Surface Water Quantity Models Progress Meeting Notes

January 4, 2016 – Teleconference

Memorandum

Re: Comments on updated Saluda SWAM Calibration Model (dated 10/23/15) (the original DNR comment Memorandum (and CDM Smith responses) on the Saluda Calibration Model dated 10/6/15 is provided at the end)

Figure A.

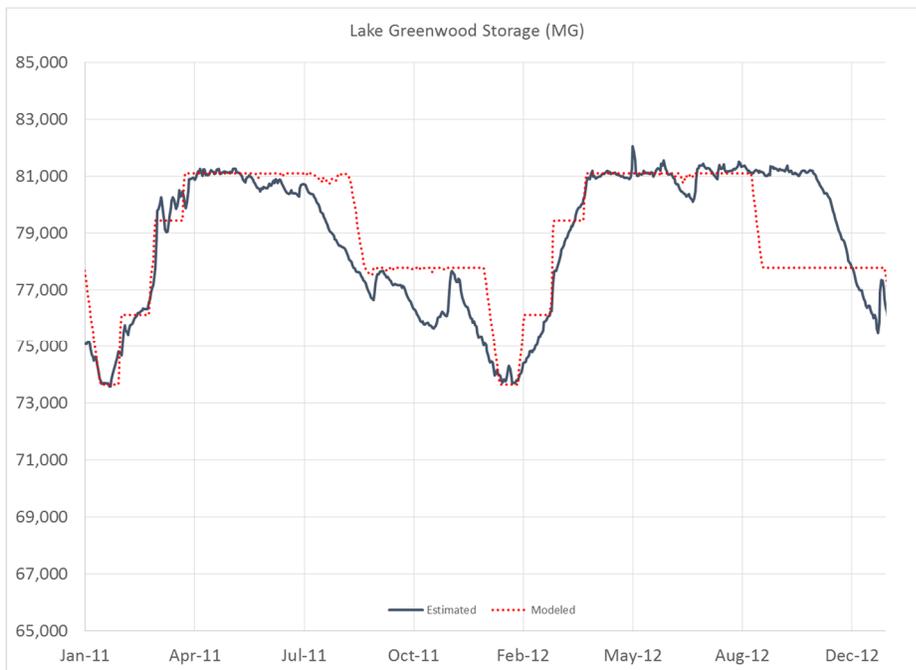
4. We still question the use of a calibration period from 1983-2013 for Lake Greenwood. In an email correspondence with CDM Smith, the recommendation was made to limit the calibration period to 1993-2009, during which one guide curve was very closely followed (Refer also to comment #1 below under the overall calibration approach from our earlier Memorandum). Assuming that modeled versus observed lake elevations for Greenwood (and Murray) are considered along with the streamflow gages to determine a good calibration, there are several reasons why we think this shorter calibration period is appropriate:

CDM Smith Response: Although the latest calibration results graph still presented a comparison of modeled vs measured lake storage values over the 1983 to 2013 period, the focus of the calibration, in terms of setting gain/loss factors, was on the 1993 to 2009

We agree that including the entire period in the calibration results graphs may cause confusion to the reader. This will be removed and Section 7 of the report will be revised to reflect the fact that calibration of the model at and immediately downstream of Lake Greenwood focused on the 1993 to 2009 period, where one guide curve was closely followed. During calibration, gain/loss factors were adjusted downstream, based on the results primarily during this period.

Figure 1. Lake Greenwood 2001 to 2003 Calibration (Drought Period) Check

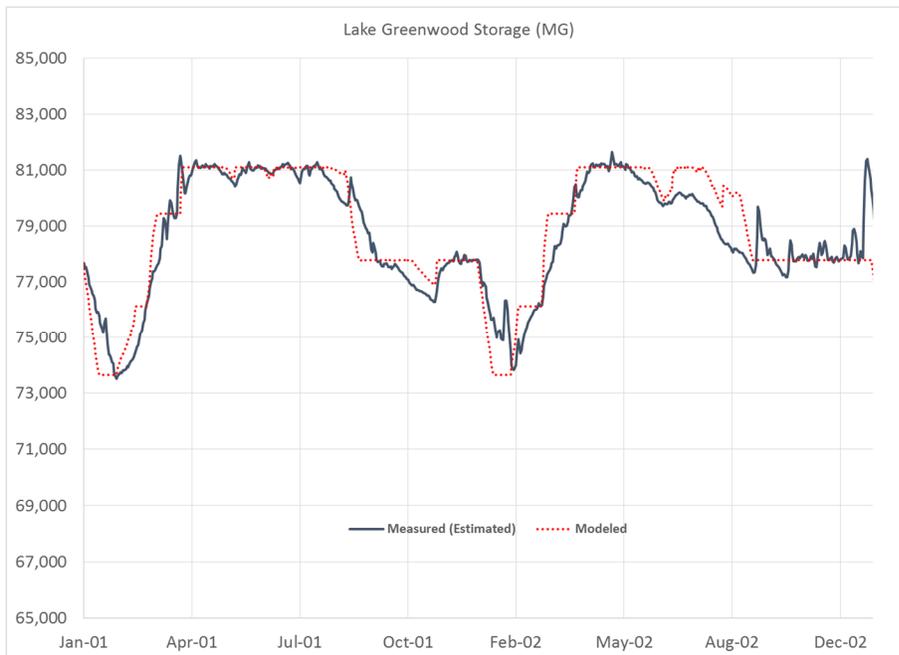
5. Refer to comment #2 below under the calibration approach. The original comment was a little unclear, though we thought this was clarified on a conference call in October. We were referring to a detailed review of a drought year(s) for Lake Greenwood and Lake Murray to test whether the model was reproducing any resulting declines in lake elevations. We still strongly recommend that the calibration/verification method incorporate such a test. This has been a fairly common practice for water allocation modeling in the Carolinas over the past decade for FERC relicensing and COE drought planning. We understand that we should not expect a *very high* degree of accuracy when trying to compare modeled elevations to observed elevations

- a. We have to have confidence that the model is representing the drought of record and perhaps other severe droughts reasonably well since these are times where water shortages are most likely to occur and are most critical for water management.
- b. Other basins have more severe drawdowns. Though this may be more challenging for the Saluda Basin, we need to develop a method to evaluate model performance during droughts to set a precedent for other basins where drawdowns are more severe.

CDM Smith Response: A focused examination of modeled vs. measured lake levels during drought periods has been added to Section 7 of the report. An example of the calibration/validation check for Lake Greenwood was presented during the December Progress Meeting. A similar analysis was completed for Lake Murray during the drought period of 2001-2002 and added to Section 7. SCE&G began lowering the lake levels in mid-2002, due to safety concerns associated with the backup dam construction, therefore drought impacts associated with potentially reduced inflow are hard to discern. In the 2007-2008 drought, the new guide curve was being followed.

Figure 1. Green line is new guide curve and green dashed is the old guide curve. PD is plant datum and NAVD is NAVD88.

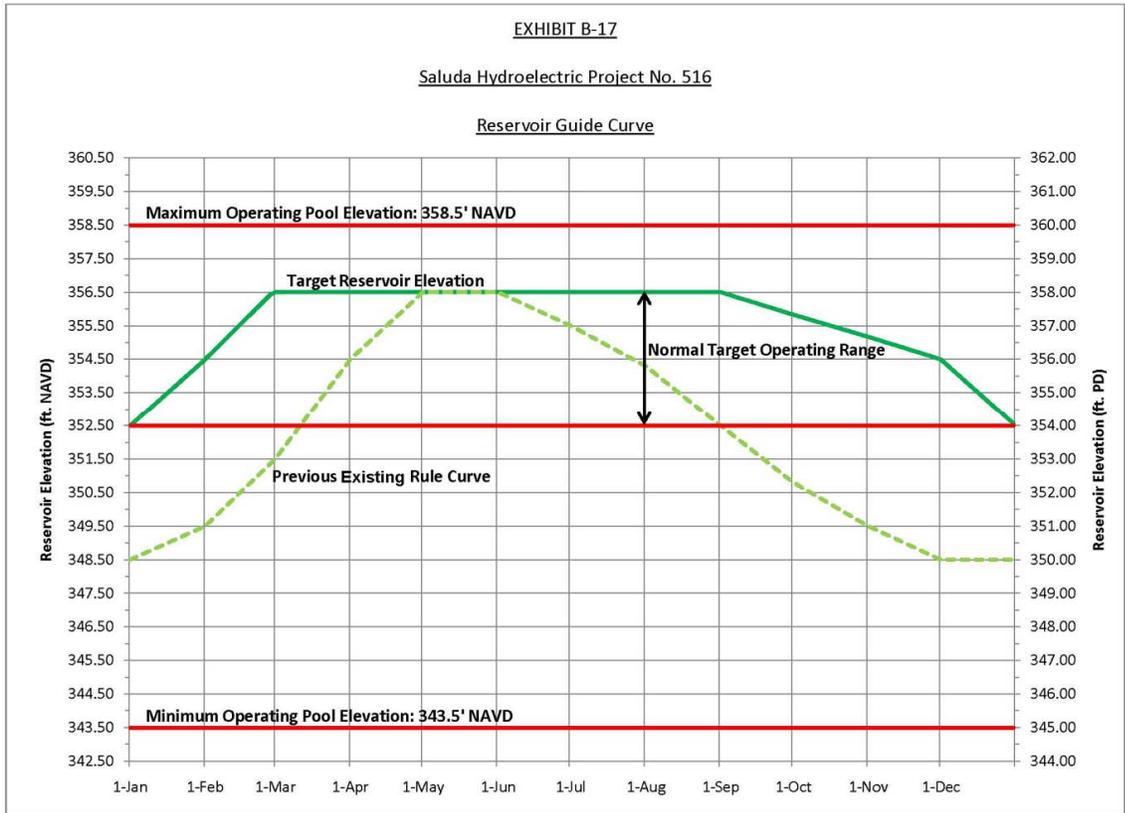
4. Lake Greenwood and Lake Murray Elevations:
 - a. Storage targets in the model for Lake Murray (and maybe Lake Greenwood) don’t appear to match any known historic guide curve that we are aware of. We believe that the elevations used to determine the storage targets in the model were incorrectly based on the NAVD88 datum instead of SCE&G’s plant datum. Or perhaps the guide curve received by CDM (ranging from 354-358 under the current guide curve or 350-358 under the previous license) was assumed to be in NAVD88 and not SCE&G’s plant datum. The maximum storage target in the model is 515000 MG which corresponds to 359.4 for plant datum and 357.9 for NAVD88; the correct maximum storage, we think, should be based on SCE&G’s 358 ft. plant datum (356.5 for NAVD88) which corresponds to approximately 493000 MG. See Figure 1 below which shows old and new guide curves (there is a 1.5 ft offset between the two datums). We also need clarification on the datum used for the USGS elevation data for Lake Murray to ensure that modeled elevations can be compared to gaged elevations appropriately. We have reached out to SCE&G and the USGS for clarification on this issue and are waiting for responses.

CDM Smith Response: We will continue to look into this. We previously attempted to resolve confusion about datums and the reported reservoir levels through communication with both SCG&E and the USGS. However, it is worth another look and we will clarify in the report text.

Figure 2a. Shift in storage range between daily and monthly timestep for Lake Murray.

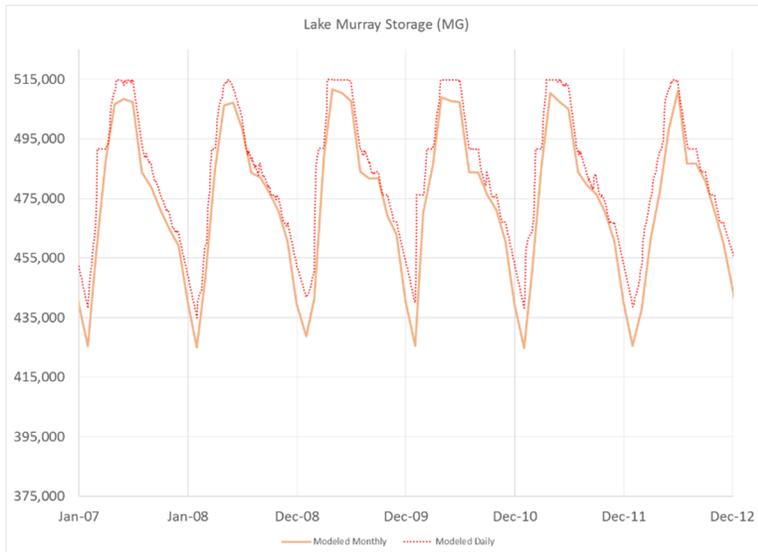
- b. The storage/elevation targets and/or range for Lake Murray and Lake Greenwood appear to change when moving from the daily timestep to the monthly timestep when looking at the hydrographs. This may partly be caused by the monthly timestep using an average target or end of month target (please verify), but we don't think this explains all the differences. (See Figure 2a and 2b). Also, observe discrepancies between the modeled daily and monthly outputs in 2008 and 2011 for Lake Greenwood. These difference, we believe, are unrealistic. We don't think that such large differences should exist by simply going from a daily to monthly timestep.

CDM Smith Response: Differences between daily and monthly models are expected. For reservoir levels, these differences are attributable to: daily vs. monthly fluctuations in river inflow data; daily vs. monthly fluctuations in evaporation rates (and corresponding reservoir surface areas); and daily vs. monthly operational decision making. Regarding the latter, the model makes decisions about releases required to achieve storage targets at the start of each timestep in the model. For the monthly model, these decisions are therefore made on a monthly basis; while for the daily model they are made on a daily basis. We expect the daily decision making to result in better accuracy in achieving prescribed storage targets, compared to the monthly (and we believe this holds up in the modeling results). That being said, the differences are only a few percent, at worst.

For a normal to above normal hydrologic year, we would expect that the max and min for a given year would be the same whether or not you were on a daily or monthly timestep since the same guide curve is used for both. Let us ask the question a different way. How come under the monthly timestep during the original 30-year calibration period, Lake Murray's modeled elevation *never* reached its max storage target during May and June?
